ADDENDUM NO. 2

Project No.
2019-167G (2-1)

**SCC LAIR
REMODEL,
2019**

**SPOKANE
COMMUNITY
COLLEGE**

**ROOF PLAN
(PARTIAL)**

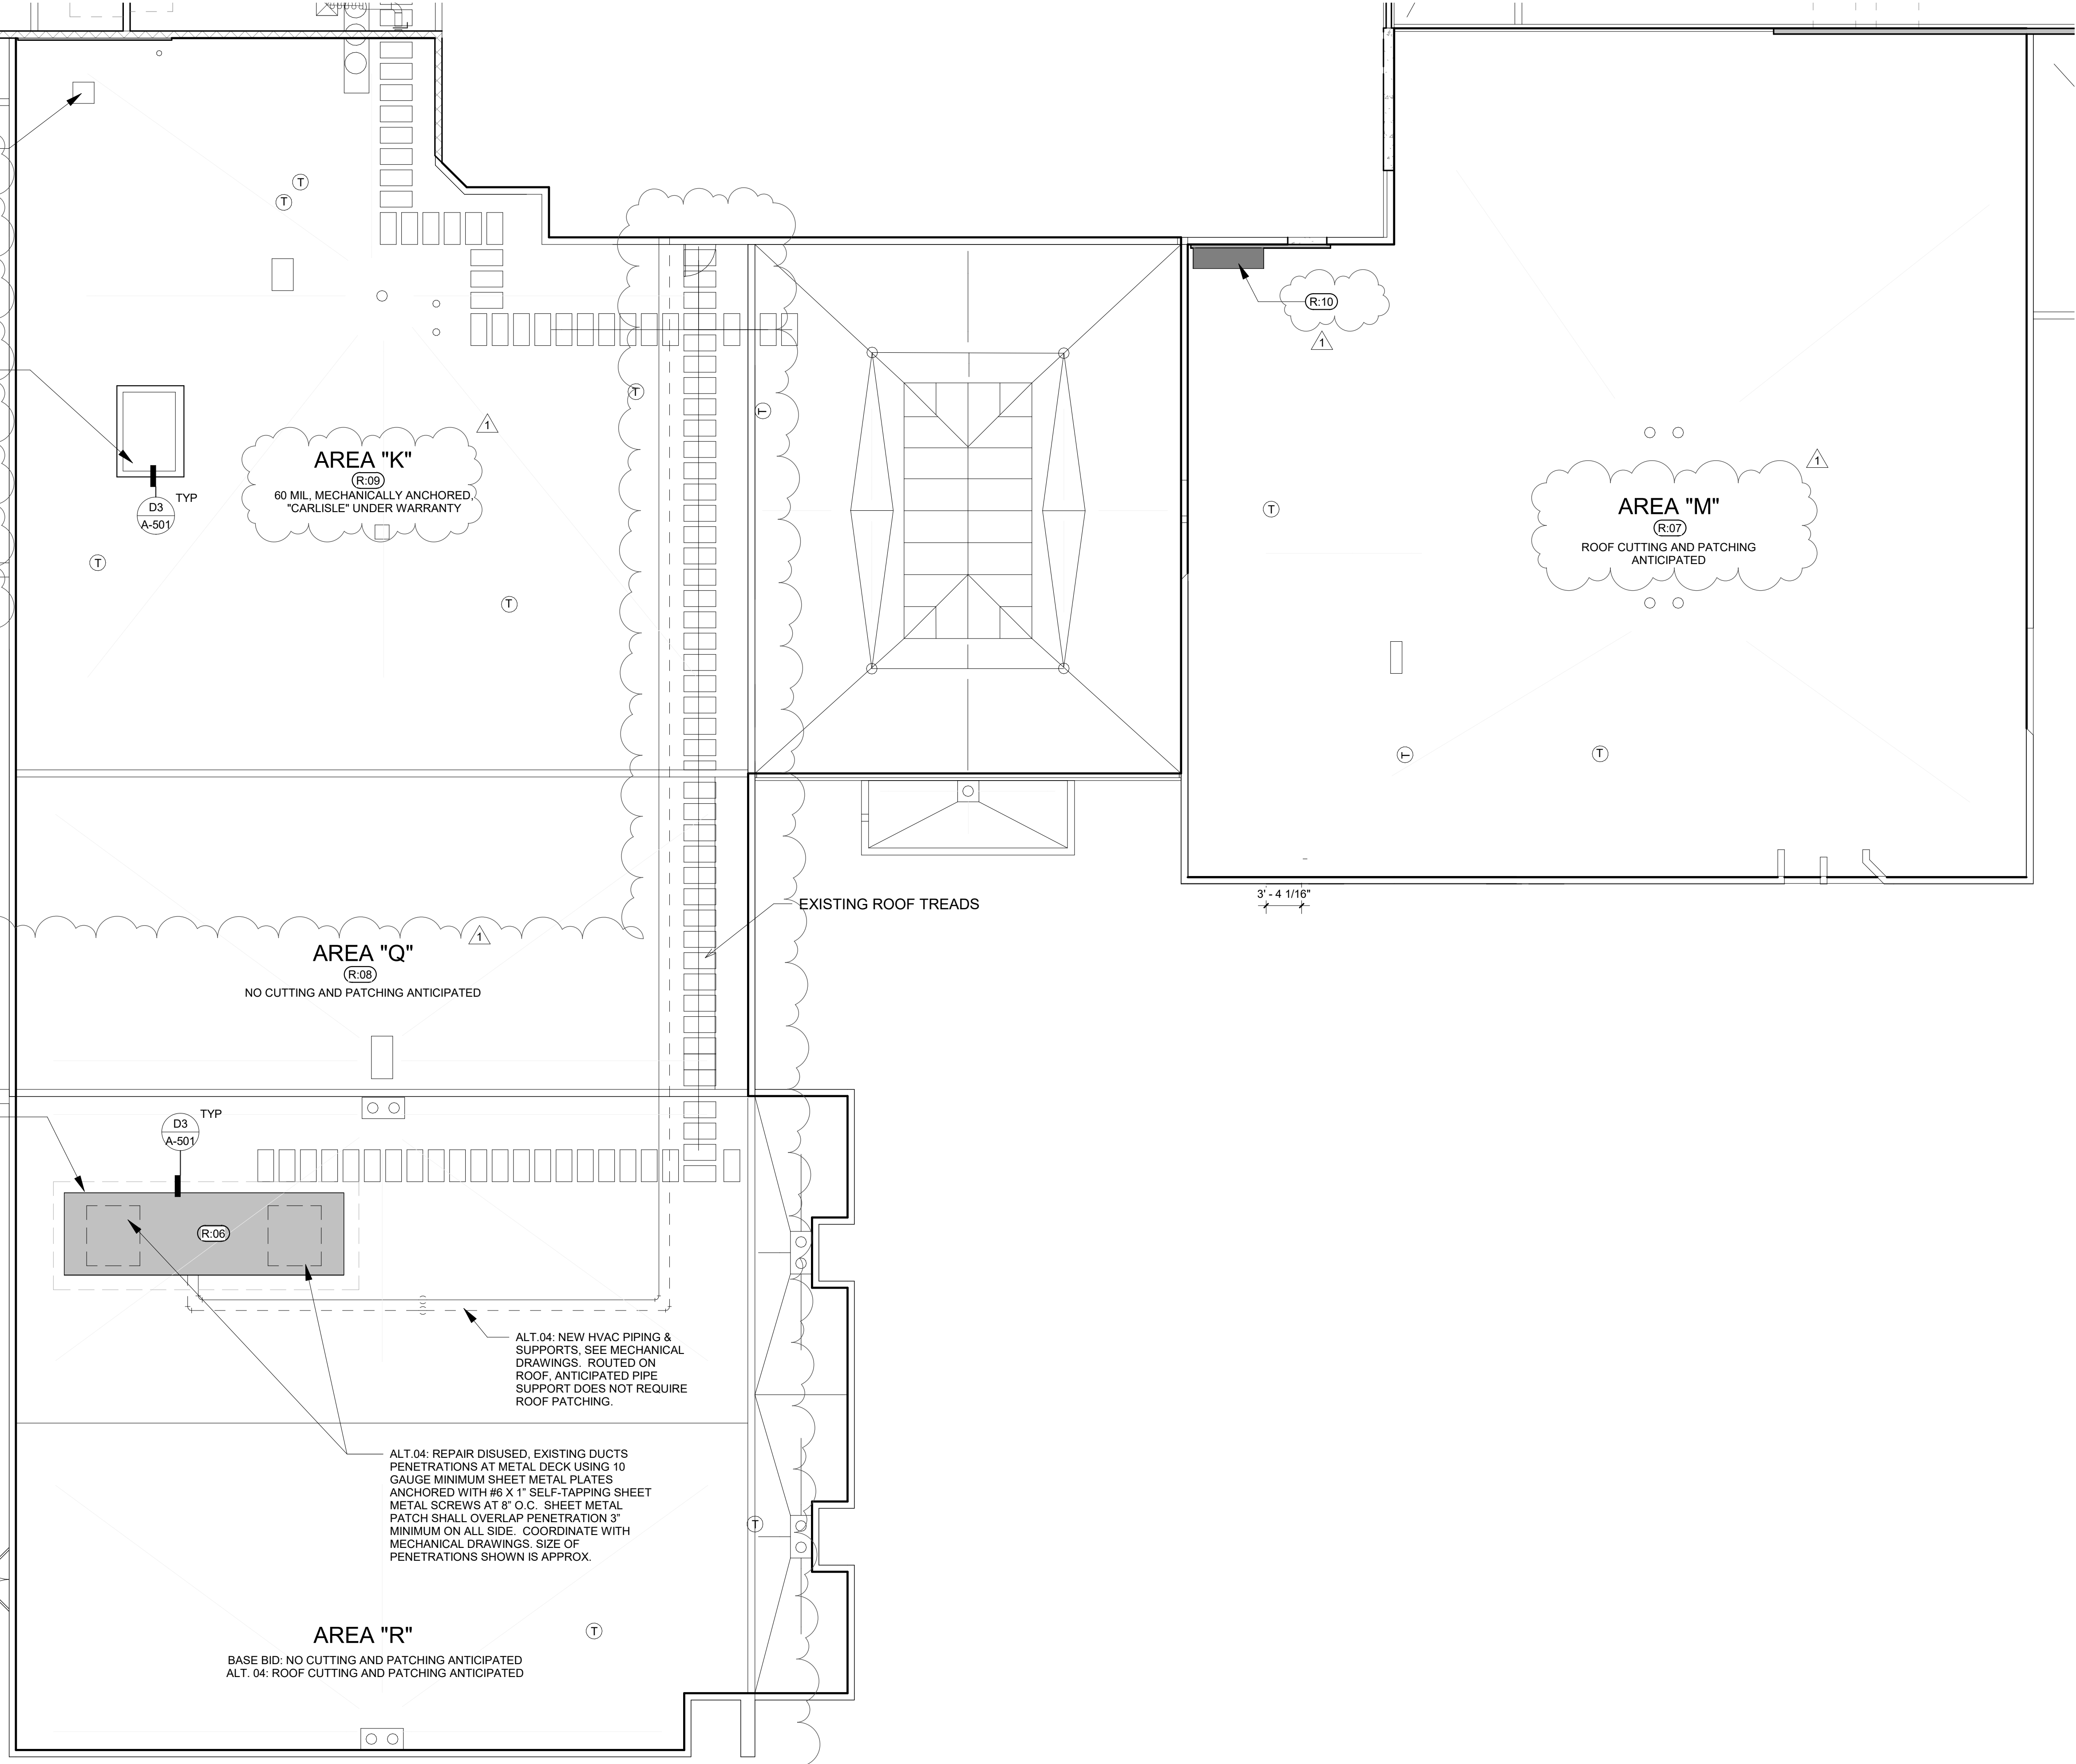
- R.06 EXISTING HVAC UNIT TO REMAIN PER BASE BID. ALT. 04: REMOVE EXISTING HVAC UNIT, CURB AND DUCT WORK AND PROVIDE NEW. WHERE DESIGNATION "MZU-5" IS REFERENCED, INCLUDING THE BID FORM AND SPEC SECTION 01 25 00 ALTERNATES, PART 3. D. BIDDERS SHALL READ AS "AHU-7"

REMOVE EXISTING FLUE. SEE MECHANICAL DRAWINGS. INCLUDE REMOVAL OF DISUSED SUPPORTING HARDWARE ASSOCIATED WITH FLUE. REPAIR DISUSED PENETRATION AT METAL DECK USING 10 GAUGE MINIMUM SHEET METAL PLATE ANCHORED WITH #6 X 1" SELF-TAPPING SHEET METAL SCREWS AT 8" O.C. SHEET METAL PATCH SHALL OVERLAP PENETRATION 3" MINIMUM ON ALL SIDE. REPAIR EXISTING TPO ROOF ASSEMBLY TO MATCH EXISTING CONDITIONS.

BASE BID ROOFTOP UNIT. SEE MECHANICAL DRAWINGS FOR NEW UNIT, CURB SIZE & DUCT PENETRATIONS. SEE DETAIL 1M-502 FOR NEW STEEL REINFORCEMENT BELOW EXISTING METAL DECK. REMOVE LIMITED QUANTITY OF EXISTING TPO ROOF ASSEMBLY. COORDINATE WITH EXISTING OPEN WEB STEEL JOISTS & PROVIDE NEW DUCT PENETRATIONS. FRAME DUCT PENETRATIONS WITH L 3" X 3" X 1/2" STEEL ANGLES AND REPAIR EXISTING 60MIL WHITE TPO ROOF ASSEMBLY TO MATCH EXISTING CONDITIONS. ROOF INSULATION SHALL EXTEND UNDER ROOFTOP UNIT EXCEPT WHERE DUCT PENETRATIONS OCCUR. INCLUDE RIGID INSULATION CRICKET AT UPHILL SIDE OF UNIT AND PREFABRICATED FLASHING BOOTS TO ADDRESS NEW ELECTRICAL CONDUITS & PIPE PENETRATIONS.

ALT. 04: ROOF TOP UNIT AND ASSOCIATED WORK IS NOT REQUIRED IF ALTERNATE 04 IS ACCEPTED.

ALT. 04: REMOVE EXISTING HVAC UNIT, CURB & ASSOCIATED DUCTS. SEE MECHANICAL DRAWINGS. INCLUDE REMOVAL, SALVAGE & REINSTALLATION OF EXISTING HYDRONIC FLUID IN CONTRACTOR PROVIDED RECEPTACLES. REPURPOSING OF EXISTING CONDUIT PENETRATIONS ARE ACCEPTABLE PROVIDED THEY COMPLY WITH CONTRACT REQUIREMENTS. REMOVE LIMITED QUANTITY OF EXISTING TPO ROOF ASSEMBLY AND REPAIR DISUSED DUCT PENETRATION AS NOTED ON THIS DRAWING.

PROVIDE NEW HVAC UNIT, CURB & ASSOCIATED DUCTS. SEE MECHANICAL DRAWINGS. COORDINATE WITH EXISTING OPEN WEB STEEL JOISTS & PROVIDE NEW DUCT PENETRATIONS. FRAME DUCT PENETRATIONS WITH STEEL ANGLES AS NOTED BELOW AND REPAIR EXISTING 60MIL WHITE TPO ROOF ASSEMBLY TO MATCH EXISTING CONDITIONS INCLUDING REAPPLICATION OF FLUID APPLIED "UNIFLEX ACRYLIC ELASTOMERIC SYSTEM" BY MANUFACTURER APPROVED APPLICATOR. ROOF INSULATION SHALL EXTEND UNDER HVAC UNIT EXCEPT WHERE DUCT PENETRATIONS OCCUR. INCLUDE RIGID INSULATION CRICKET AT UPHILL SIDE OF UNIT AND PREFABRICATED FLASHING BOOTS TO ADDRESS NEW ELECTRICAL CONDUITS & PIPE PENETRATIONS.

SEE DETAIL D3A-501 FOR CURB FLASHING. SEE DETAIL 1M-502 FOR NEW STEEL REINFORCEMENT BELOW EXISTING METAL DECK. SEE DETAIL 5P-501 FOR CONDENSATE TRAP.

**LEVEL 01
(PARTIAL) -
REFLECTED
CEILING
PLAN**

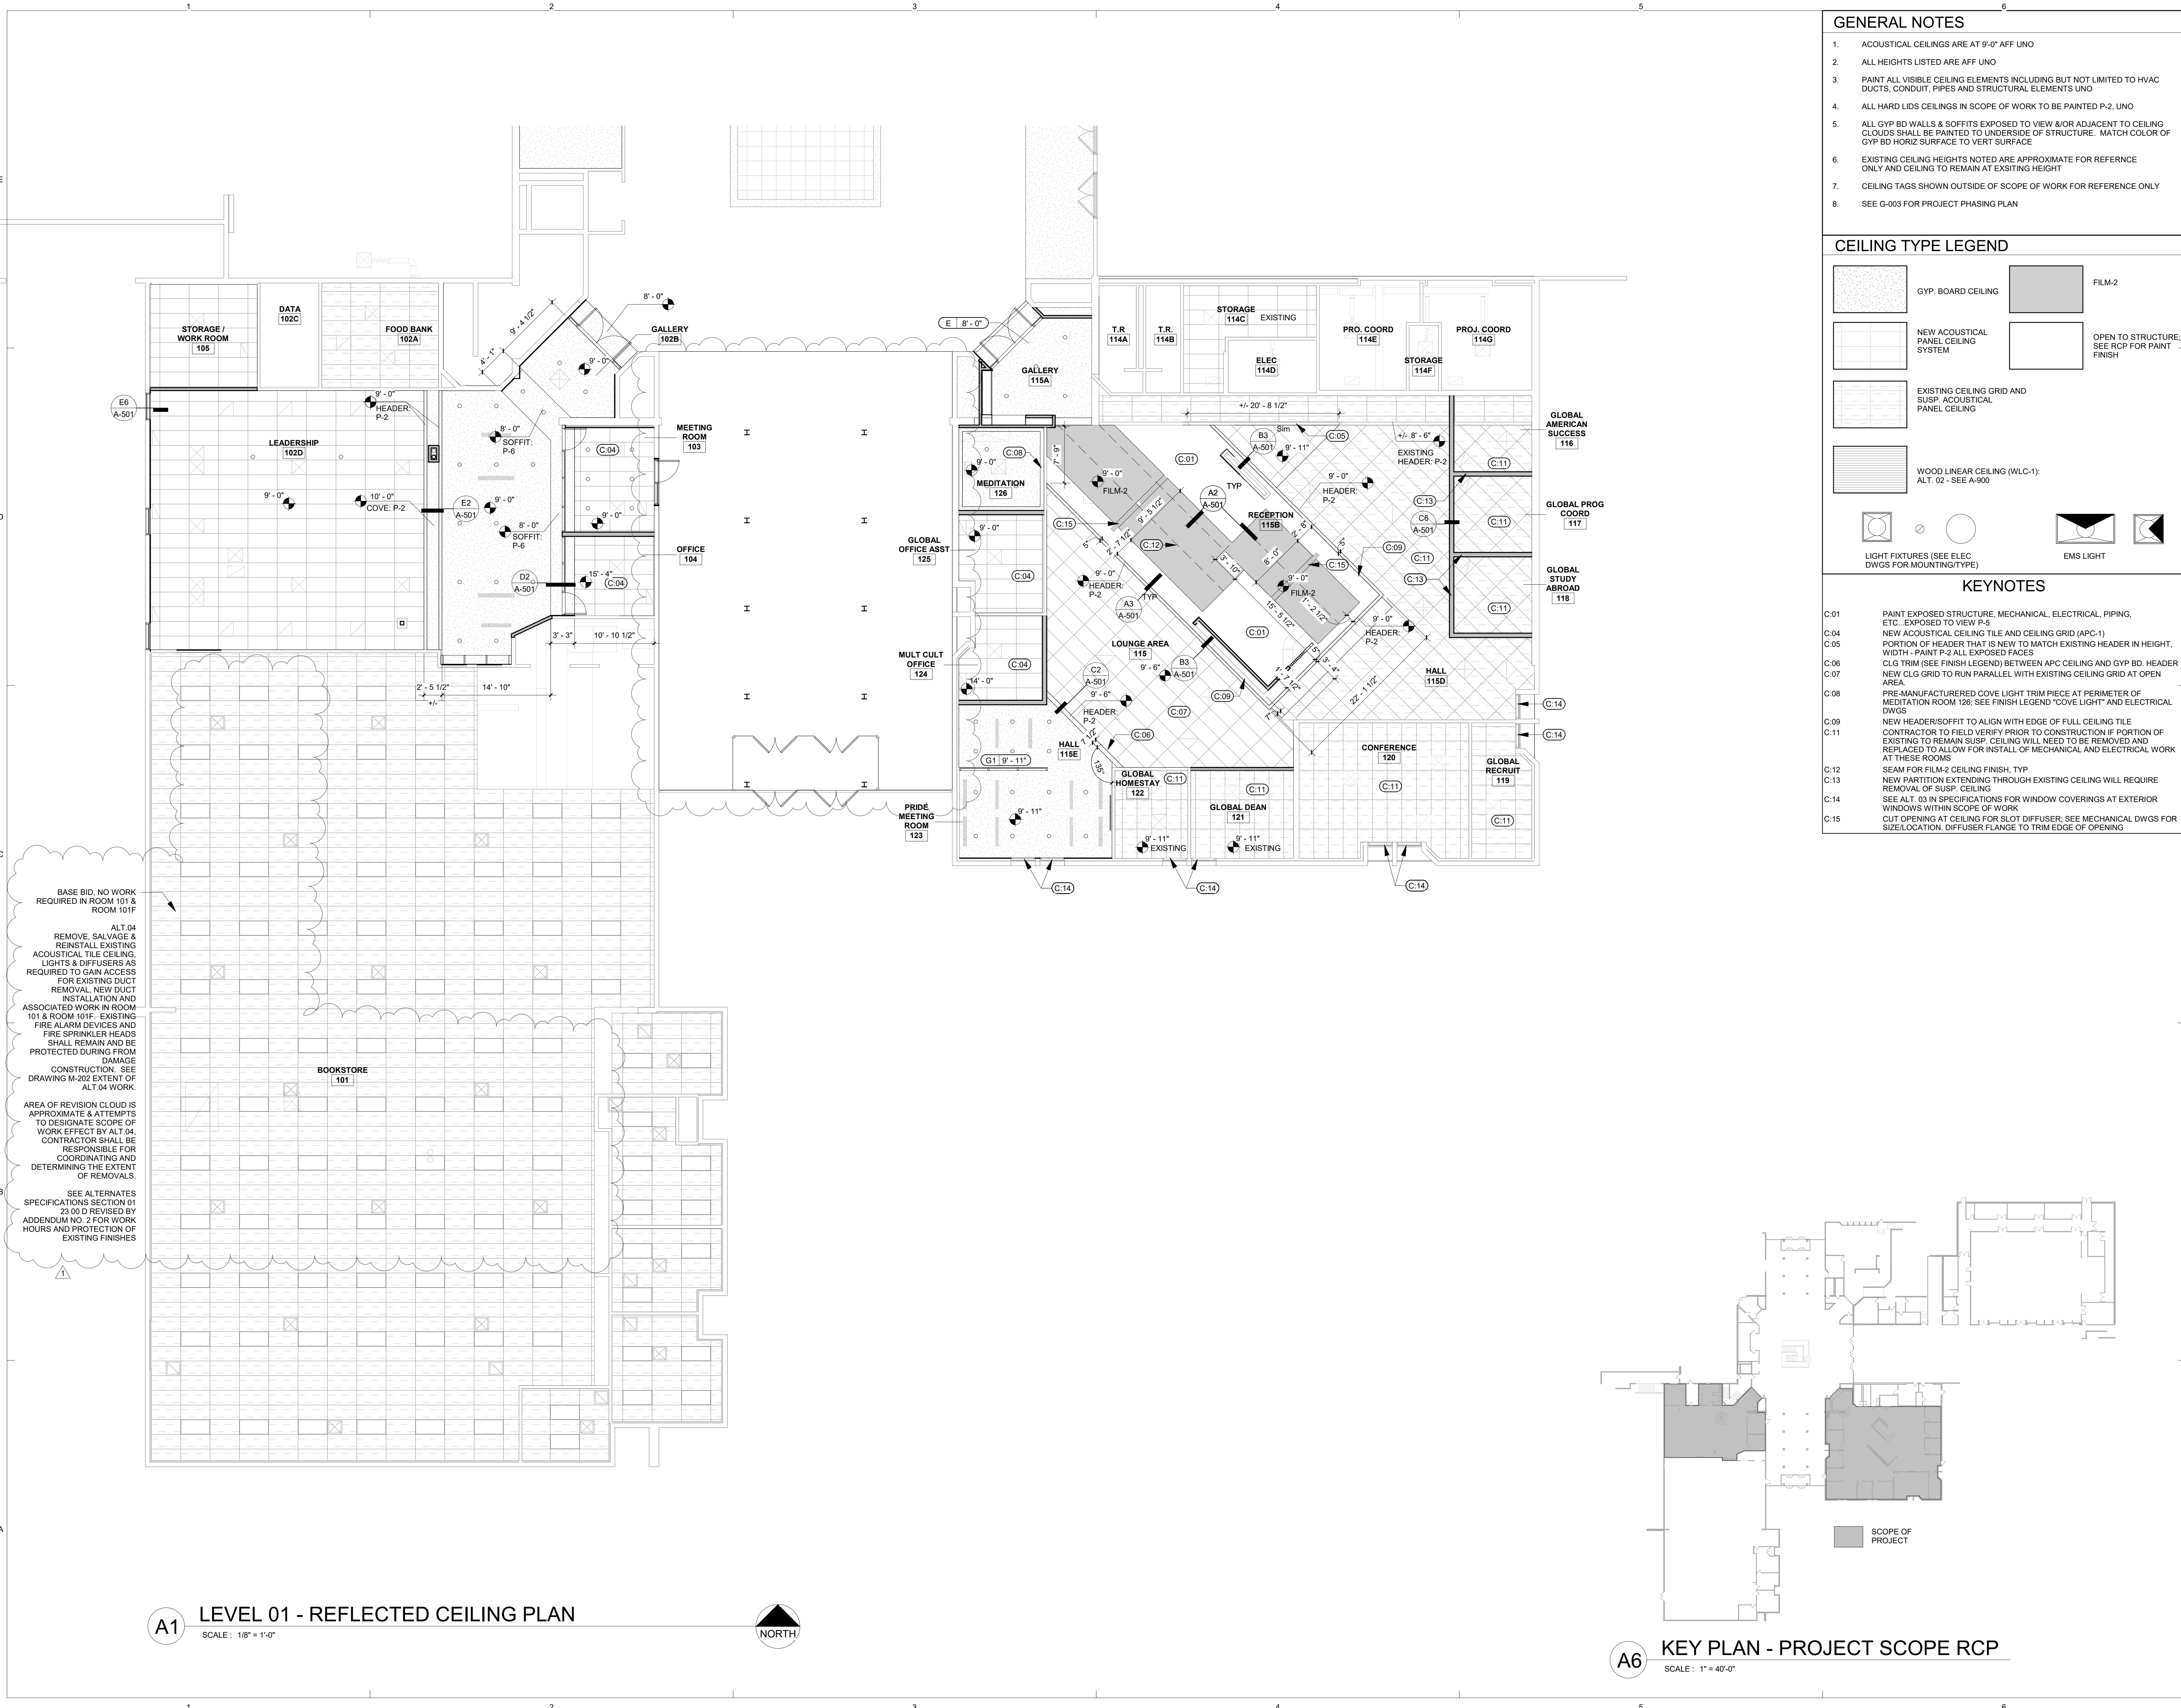
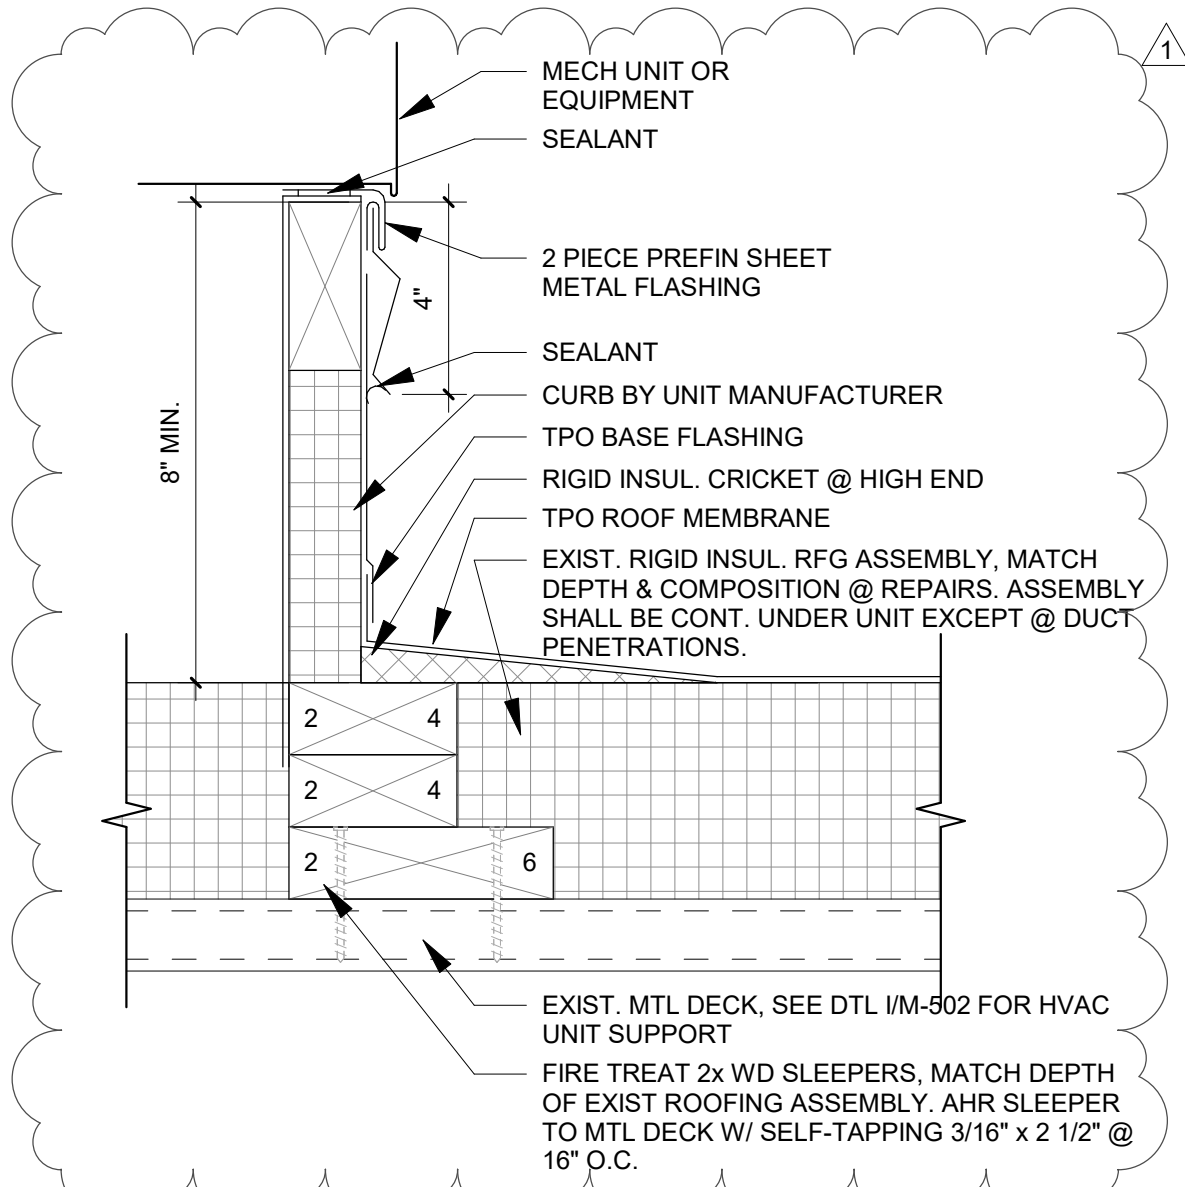
BASE BID, NO WORK REQUIRED IN ROOM 101 & ROOM 101F

ALT. 04 REMOVE SALVAGE & REINSTALL EXISTING ACOUSTICAL TILE CEILING, LIGHTS & DIFFUSERS AS REQUIRED TO GAIN ACCESS FOR EXISTING DUCT REMOVAL. NEW DUCT INSTALLATION AND ASSOCIATED WORK IN ROOM 101 & ROOM 101F. EXISTING FIRE ALARM DEVICES AND FIRE SPRINKLER HEADS SHALL REMAIN AND BE PROTECTED DURING FROM DAMAGE CONSTRUCTION. SEE DRAWING M-202 EXTENT OF ALT. 04 WORK.

AREA OF REVISION CLOUD IS APPROXIMATE & ATTEMPTS TO DESIGNATE SCOPE OF WORK EFFECT BY ALT. 04. CONTRACTOR SHALL BE RESPONSIBLE FOR COORDINATING AND DETERMINING THE EXTENT OF REMOVALS.

SEE ALTERNATES SPECIFICATIONS SECTION 01 23 01.0 REVISED BY ADDENDUM NO. 2 FOR WORK HOURS AND PROTECTION OF EXISTING FINISHES

D3 **EQUIPMENT CURB FLASHING**

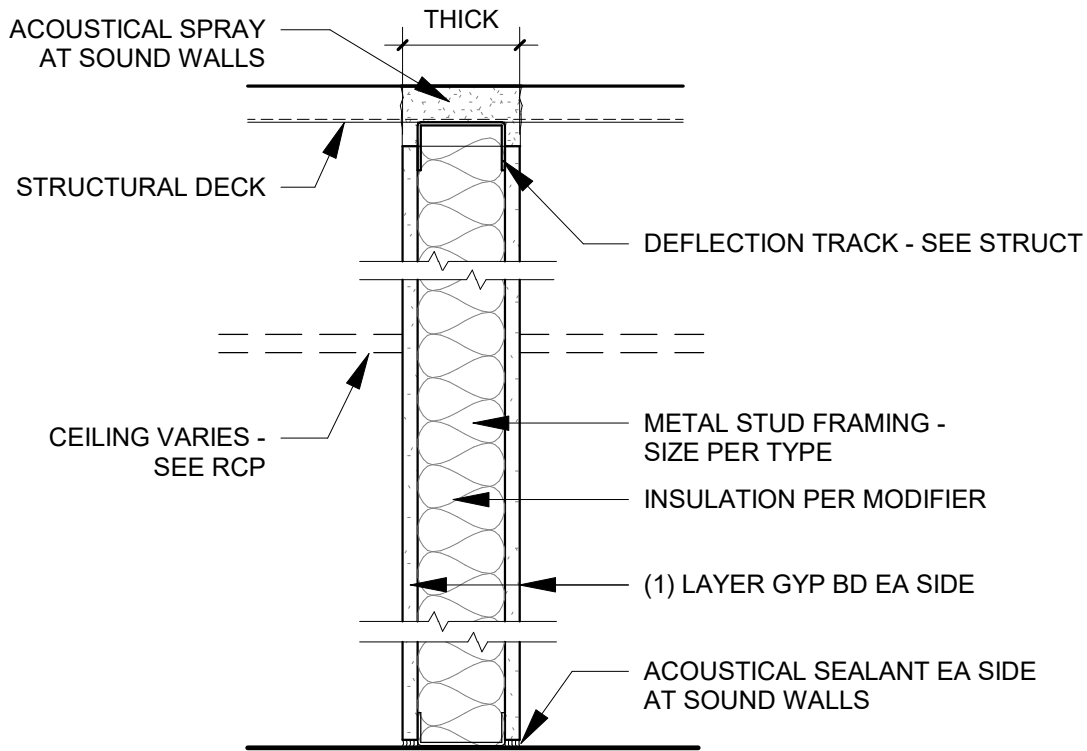
PROJECT SCC LAIR REMODEL, 2019 2019-010		ADDENDUM # 2		
	DATE 01-15-20	DRAWN RLP	DWG. NO.	JOB NO. 2019-010	REF. SHT. A-501
	DESCRIPTION DETAIL D3/A-501 REVISED
